# Access Compliance Report Public Rights-of-Way (Curb Ramps)

| Main Street: DORRANCE_DR |                                  | Cross Street: DORRANCE_DR |                        | Location:       | E  |
| ADA ID: RPRK211110131153 | Ramp Type:Type 1 - Perpendicular | Initial Pass/Fail: Pass   | Overall Compliance: No | Severity Score: | 35 |

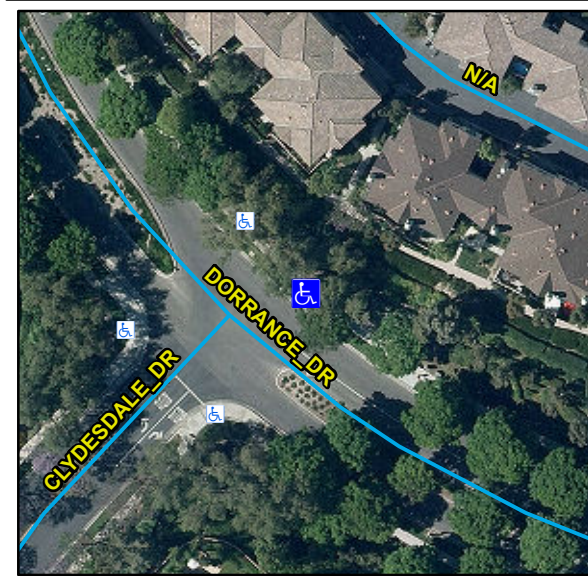
**R304.2.2, R304.5.3, R305, R304.5.4, STD 1115**

| Compliance | Description                                  | Data | Compliance | Description                   | Data   |
|------------|----------------------------------------------|------|------------|-------------------------------|--------|
| No         | Ramp Cross Slope (%)                         | 6    | N/A        | Flare Traversable LT          | No     |
| No         | Landing Cross Slope (%)                      | 9.7  | No         | DWS Provided                  | No     |
| No         | Gutter Run Slope (%)                         | 7.1  |            | Road Cross Slope (%)          | N/A    |
| No         | Gutter Cross Slope (%)                       | 9    |            |                               |        |

**Remove & Replace Entire Ramp. Remove & Replace Gutter.**
